ENGINE SYSTEMS, INC.

Subject: 10CFR21 Reporting of Defects and Non-Compliance -
Engine Systems, Inc. Report No. 10CFR21-0081

Refurbished Woodward EGB governor/actuators

Report No. 10CFR21-0081

EXHIBIT 1

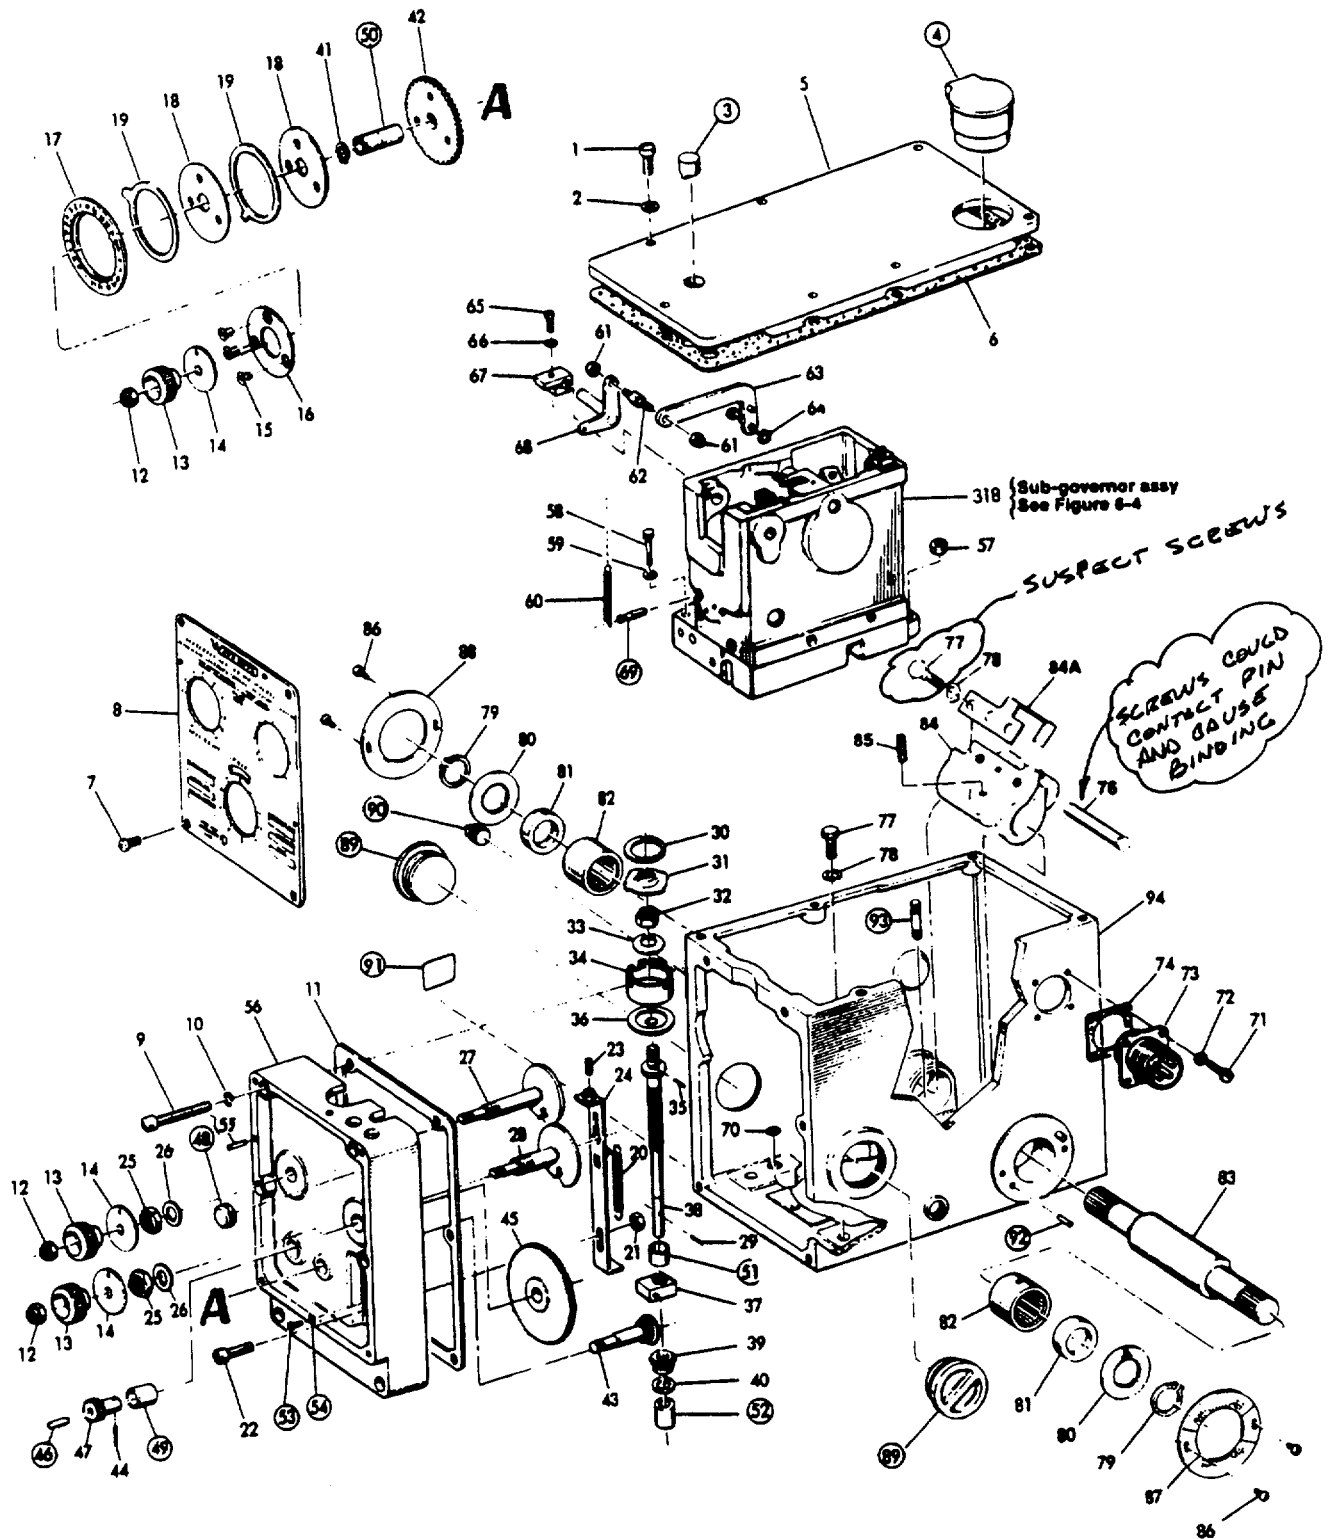
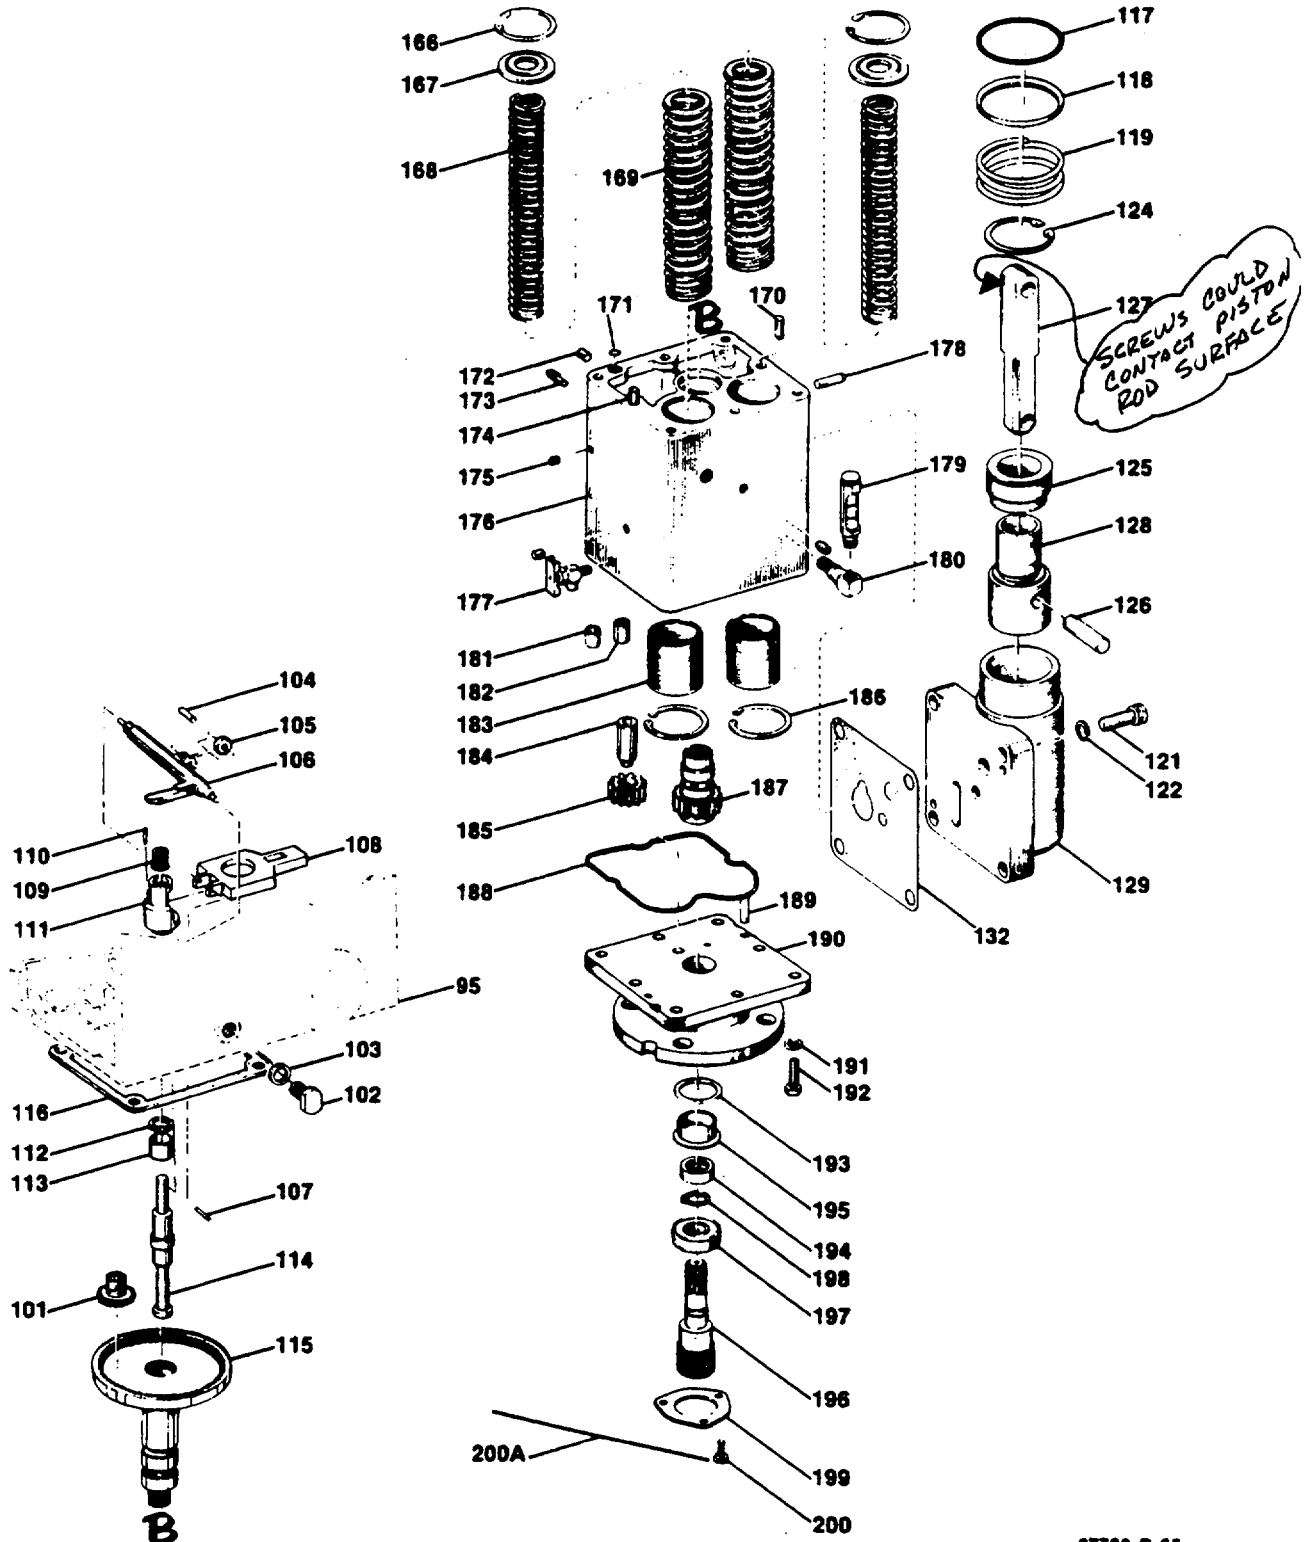
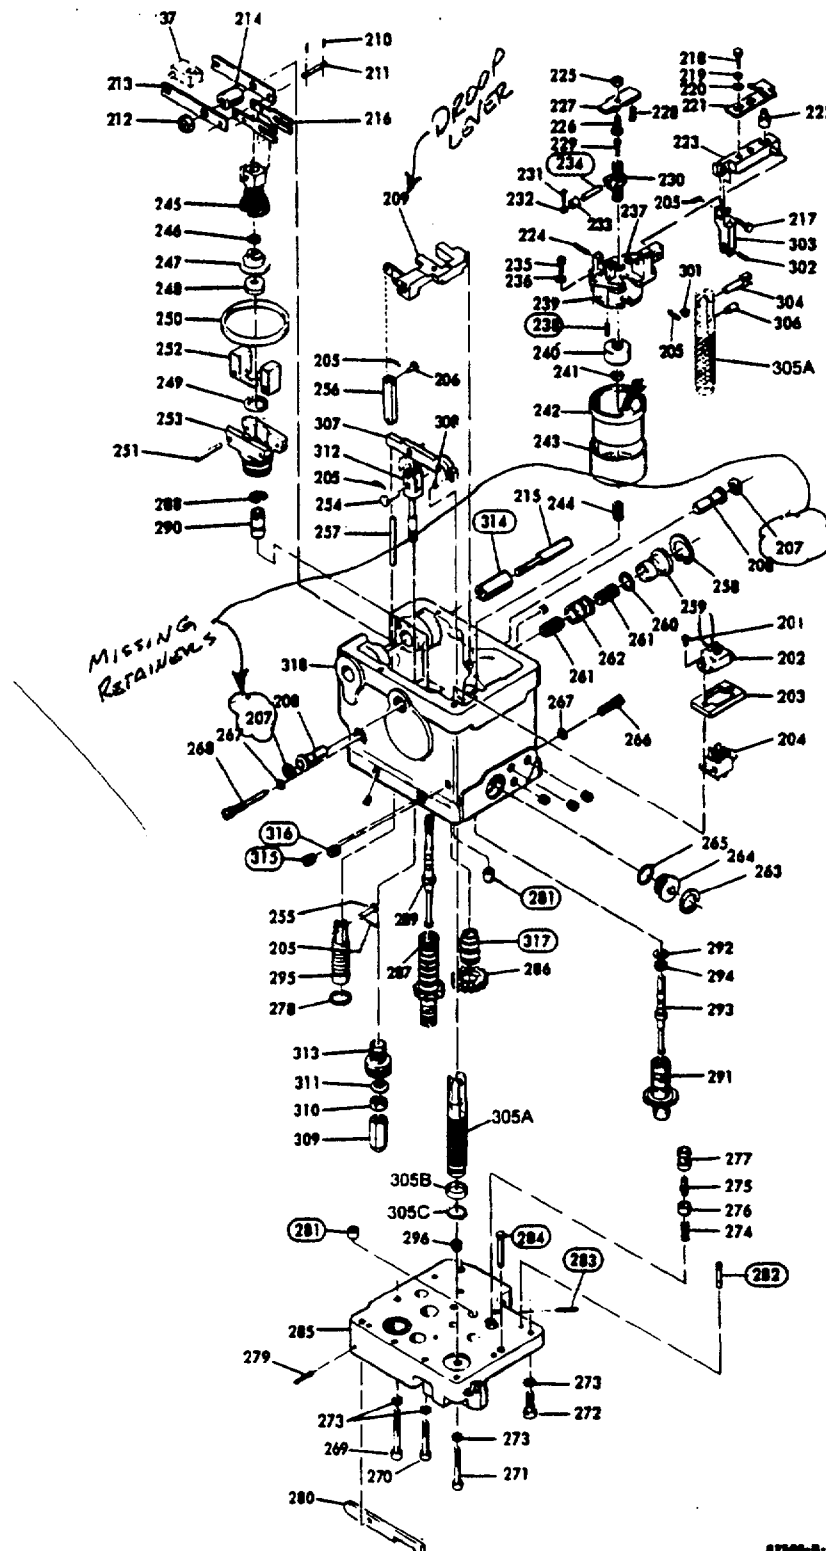
Engine Systems Inc. (ESI) has received notification about a potential problem with some refurbished Woodward EGB governor actuators. One problem was recently reported by V.C. Summer Nuclear Station, via Power Reactor Event Number 37788. Apparently, a governor experienced binding of the terminal shaft due to incorrectly applied clamping screws. ESI was not notified about this occurrence until after the Event Report was issue; therefore, ESI was not able to verify/evaluate the actual components involved. Another problem was also reported by J.A. Fitzpatrick Nuclear Plant with this governor. Operability problems were observed and an investigation revealed that the droop lever pivot pin retaining rings were omitted during reassembly of the governor. Due to the missing retaining rings, the pins eventually backed out, releasing the droop lever. This caused the mechanical speed setting to drop and interfere with electric governor operation (limited load carrying capability). A parts breakdown for the EGB is provided in Exhibit 1 with the above parts annotated.

ESI recommends returning the suspect governors to ESI for a completed tear-down inspection. ESI will reassemble and functionally test to Woodward specifications. NOTE: Even though the V.C Summer governor screw length issue was corrected, we still recommend a complete tear-down to verify all refurbishment activity is within specifications. The Fitzpatrick unit (s/n 2185499) was recently returned to ESI to replace the missing terminal shaft retaining rings. A complete tear-down inspection was performed at that time; no further action on this governor is required. Contact ESI's Customer Service Department for return instructions.
